## ENGINE IDLE & FUEL VAPOR IN CESSNA 172R / 172S

### A Historical Compilation of Service Publications

Airworthiness Concern Letter

Figure 1. Fuel Flow Divider (Sheet 1)

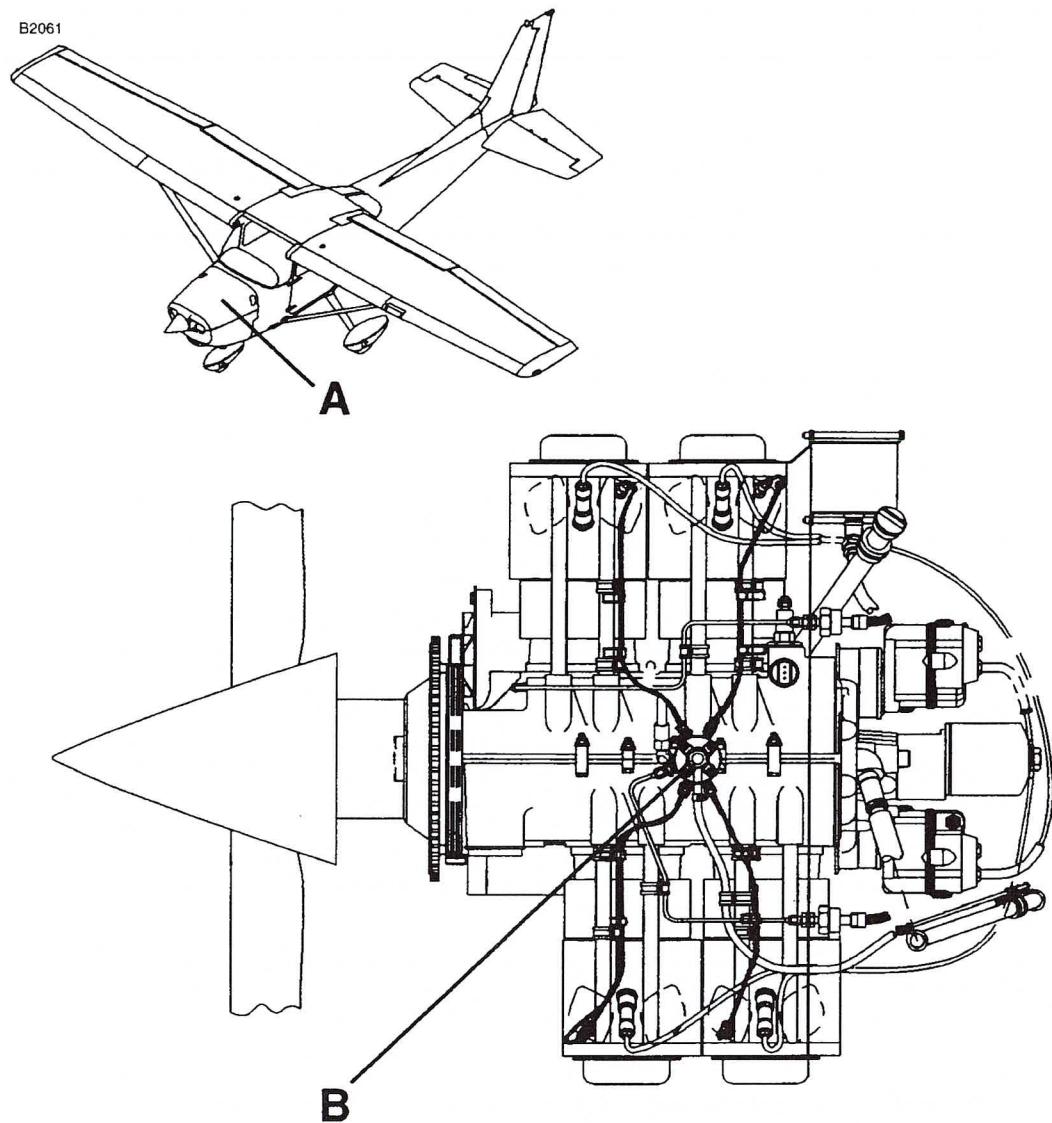
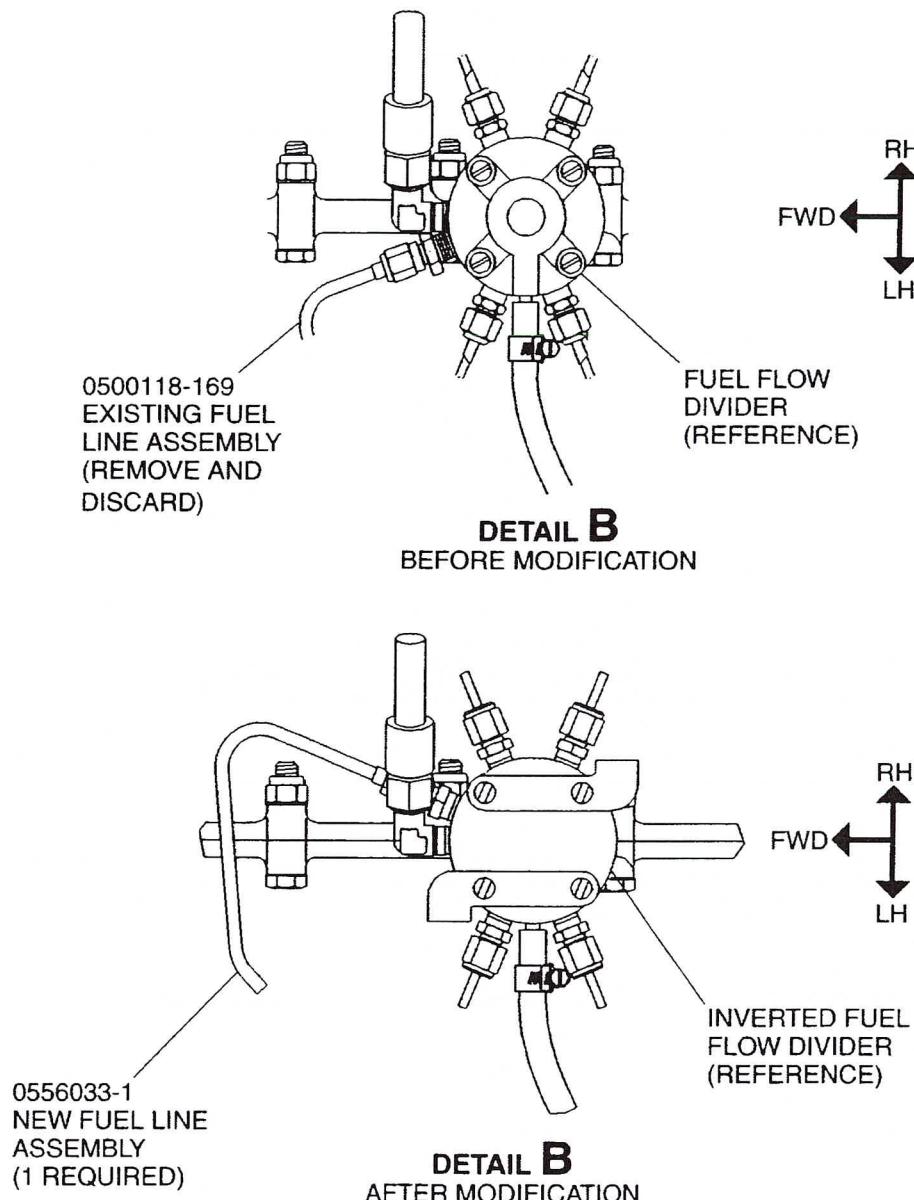
To aid in reducing possible fuel vapor during ground operations, the engine fuel flow divider installation may be modified by inverting the flow divider.

1. Electrically ground the airplane and turn all switches to the "OFF" position.
2. Remove upper and lower engine cowling. (Refer to the Model 172 Series 1996 And On Maintenance Manual, Chapter 71, Cowling - Maintenance Practices.)
3. Disconnect electrical power from the airplane by disconnecting the battery and external power. Attach maintenance warning tags to the battery and external power receptacle stating: **DO NOT CONNECT ELECTRICAL POWER - MAINTENANCE IN PROGRESS.**
4. (Refer to Figure 1, Sheet 1 and Sheet 2.) Modify the engine fuel flow divider as directed by Textron/Lycoming Service Instruction No.1502 (or latest revision).

**NOTE:** While accomplishing Step 8. of the Lycoming Service Instruction, remove and discard the existing 0500118-169 Fuel Line Assembly and install the new 0556033-1 Fuel Line Assembly.

Figure 2. Fuel Flow Divider Hose Routing (Sheet 1)

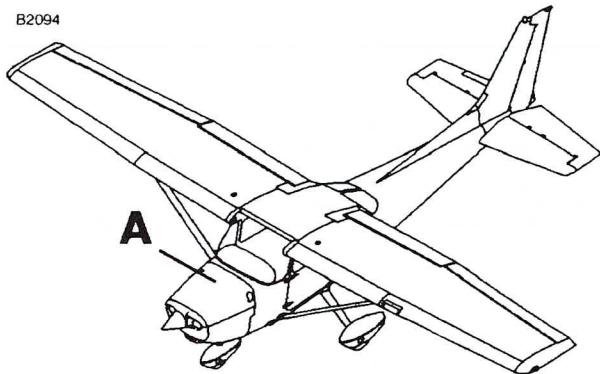
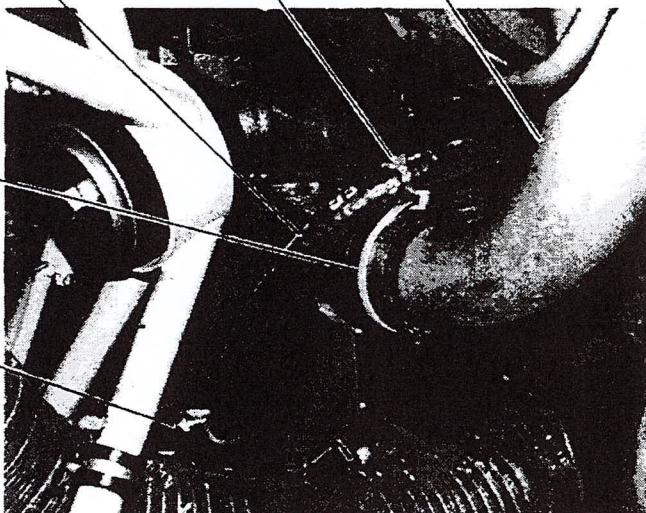
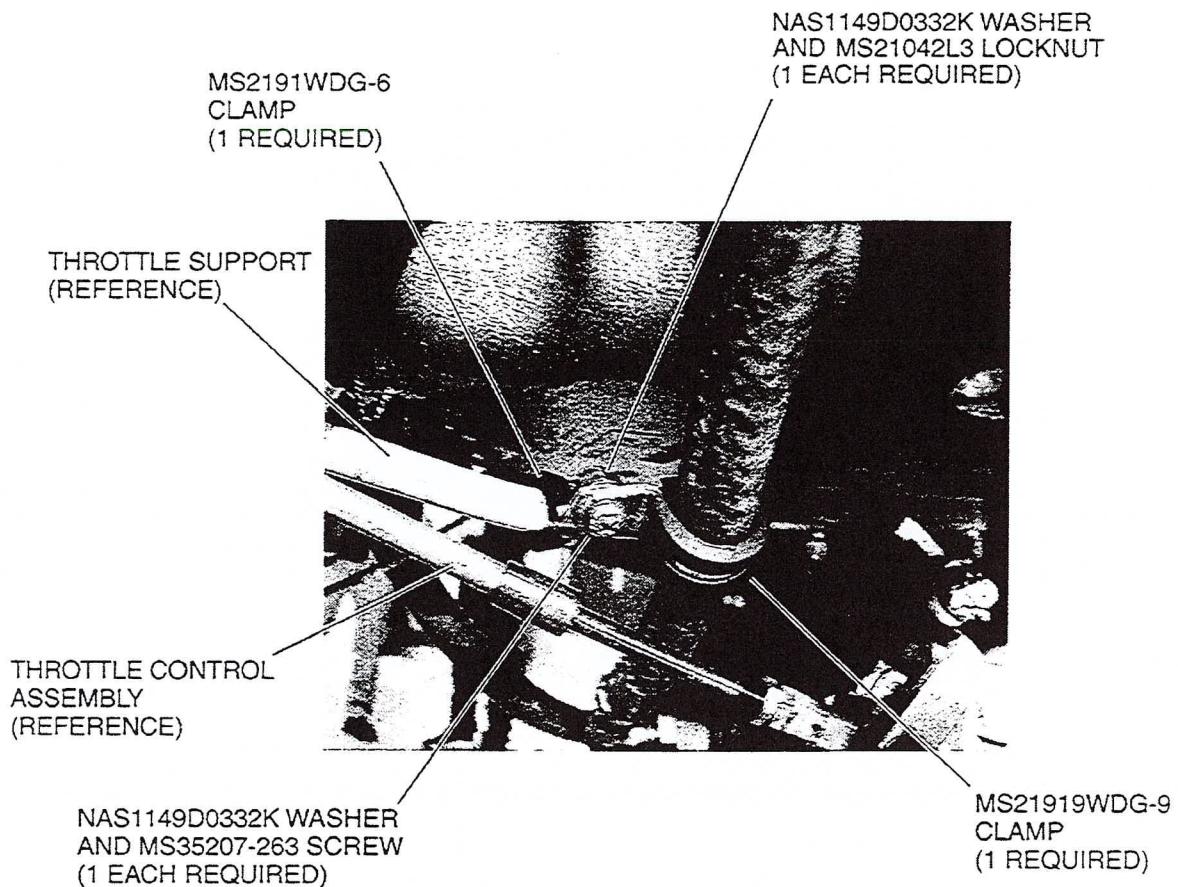
- A. (Refer to Figure 2, Sheet 1 and Sheet 2.) Re-position hose assembly over intake manifold and up to fuel flow divider.
- B. Secure line with one (1) MS21919WDG6 Clamp, one (1) MS21919WDG9 Clamp, two (2) NAS1149D0332K Washers, one (1) MS35207-263 Screw and one (1) MS21042L3 Locknut to the throttle support.

- C. (Refer to Figure 2, Sheet 1.) Secure hose assembly to intake manifold with one (1) each S2209-5 and S2209-1 Nylon Tie.

Figure 1.

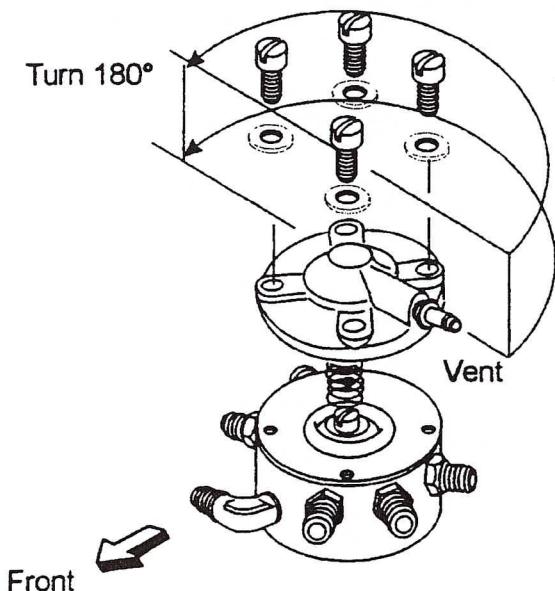
To reduce the possibility of vapor related problems in aircraft employing IO-360-L2A model engines, the flow divider should be modified into an inverted flow divider.

- a. Remove the lockwire, screws and washers from the top of the flow divider assembly. (Figure 1.)
- b. With the cap vent pointing left, slightly lift the manifold cap, making sure that it is separated from the diaphragm. Then carefully rotate it until cap vent points right. (180° from original position.) (Figure 1.) Be sure that the spring held in place by the cap is not dislodged.

Figure 2.

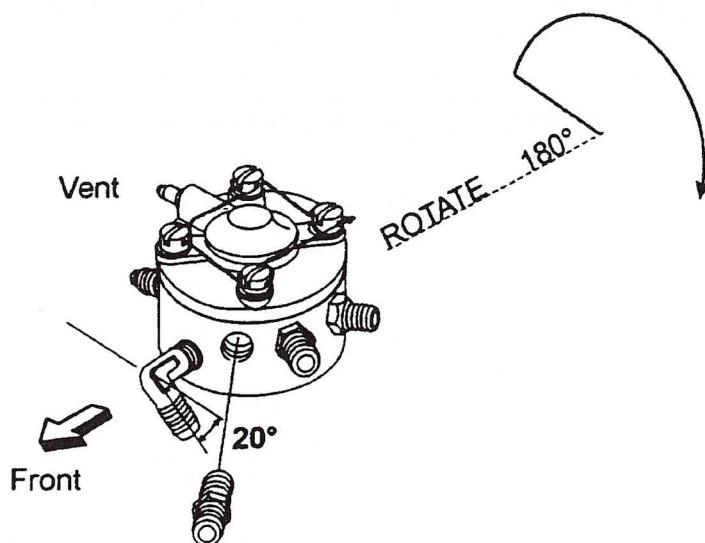
- d. To allow removal and installation of the 90° fuel inlet elbow, first remove the fuel gage fitting close to the elbow on the forward side of the flow divider. (Figure 2.)

- e. Holding the flow divider with the manifold cap up, remove the 90° elbow P/N MS20822-4 and install the new 90° elbow with the elbow positioned below the gage fitting port pointed left and tilted approximately 20° below horizontal. Reinstall gage nipple. The angle allows clearance for hose connections. Before reinstalling the fittings, apply Loctite Hydraulic Sealant or an equivalent fuel soluble sealant sparingly. Do not apply sealant to the first two lead threads. (Figure 2.)

Figure 1. Fuel Return System Installation (Sheet 1)

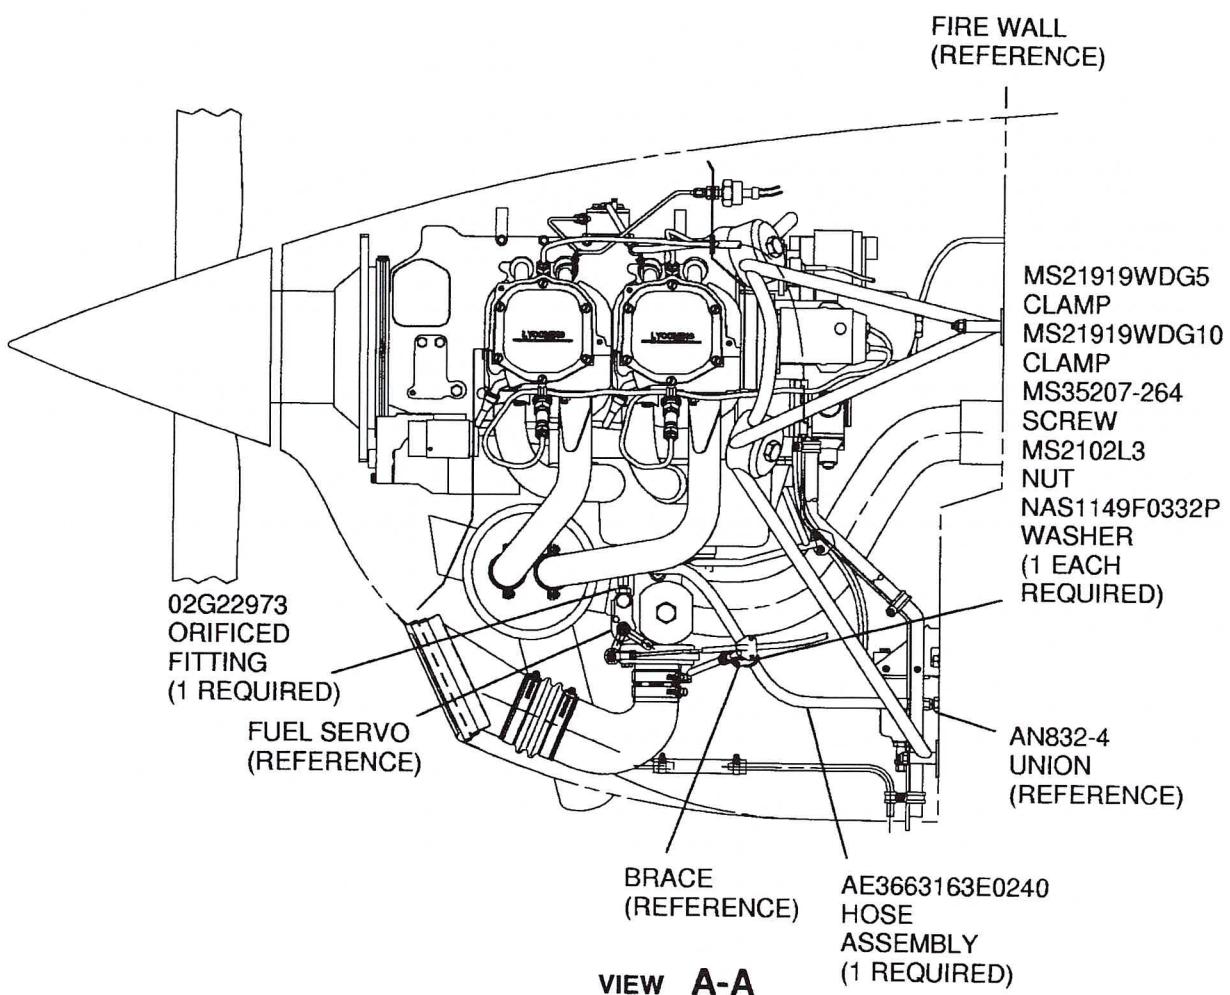
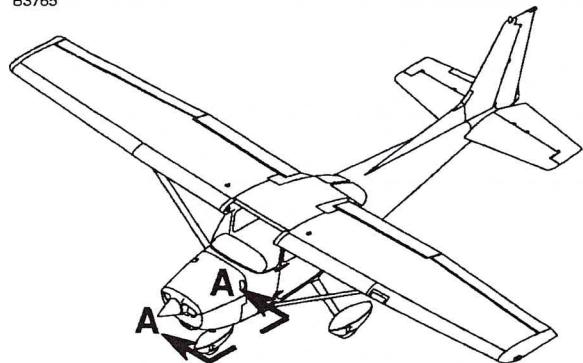
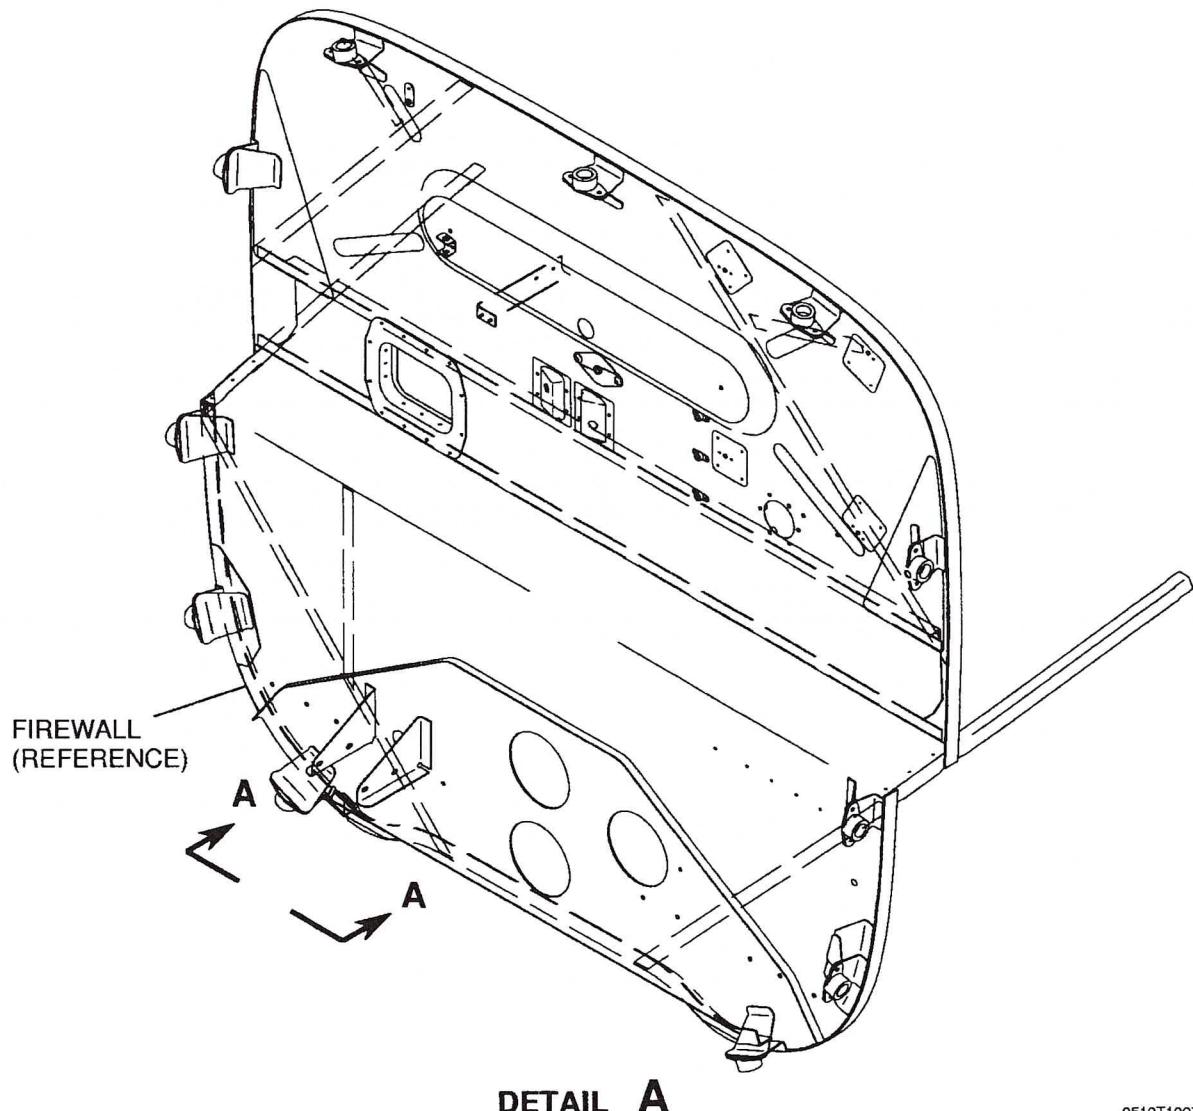
To provide parts and instructions to install an engine fuel return system.

5. Defuel the airplane. (Refer to the Model 172 Series 1996 and On Maintenance Manual, Fuel - Servicing.)
6. Remove the copilot seat and carpet. (Refer to Chapter 25, Front Seats and Rails - Maintenance Practices and Chapter 25, Interior Upholstery - Maintenance Practices.)
  - A. Remove the copilot side 0515075-40 Panel to get to the fuel reservoir assembly.
  - B. Remove the copilot side 0513512-9 Forward Floorboard and the access panel behind the rudder pedals to get to the fuel reservoir.
7. (Refer to Figure 1.) Remove the safety wire and plug in the forward top side of the fuel servo and install a 02G22973 Orificed Fitting with a MS29512-04 O-Ring.

Figure 2. Fuel Return Firewall Hole Installation (Sheet 1)

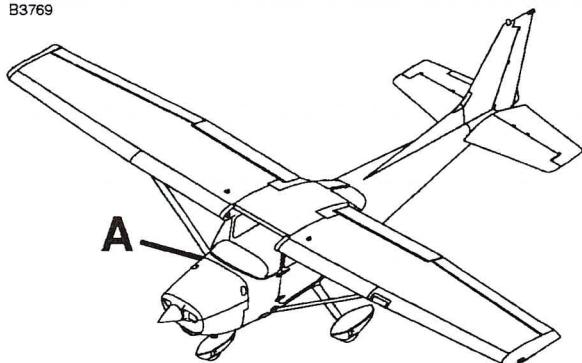
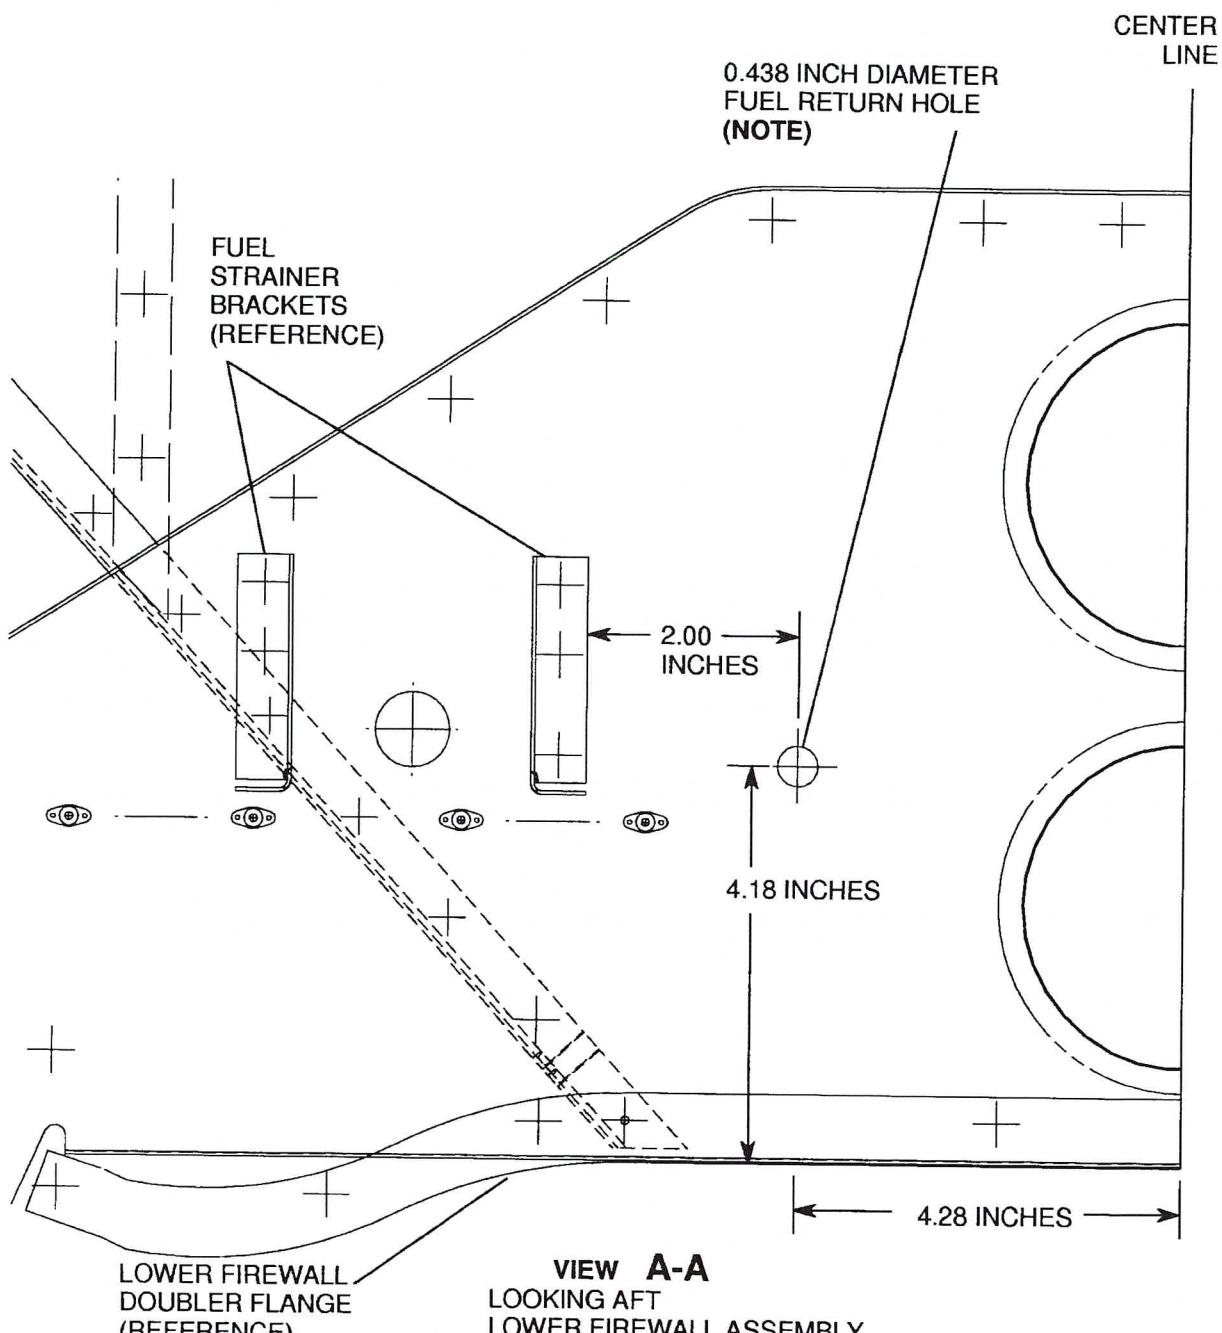
8. (Refer to Figure 2, Sheet 1 and 2.) Drill 0.438 inch diameter fuel return hole in the firewall as shown.
9. (Refer to Figure 3, Sheet 2.) Install a AN832-4 Union, NAS1149F0932P Washer, and AN924-4 Nut in the firewall fuel return hole as shown.
10. (Refer to Figure 1, View A-A.) Install a AE3663163E0240 Hose Assembly between the fuel servo orificed fitting and the firewall AN832-4 Union.

**NOTE:** DRILL A 0.438 INCH DIAMETER HOLE IN THE LOCATION SHOWN AND MAKE SURE YOU DO NOT DRILL INTO ANY OBSTRUCTIONS OR STRUCTURE ON THE AFT SIDE OF FIREWALL.
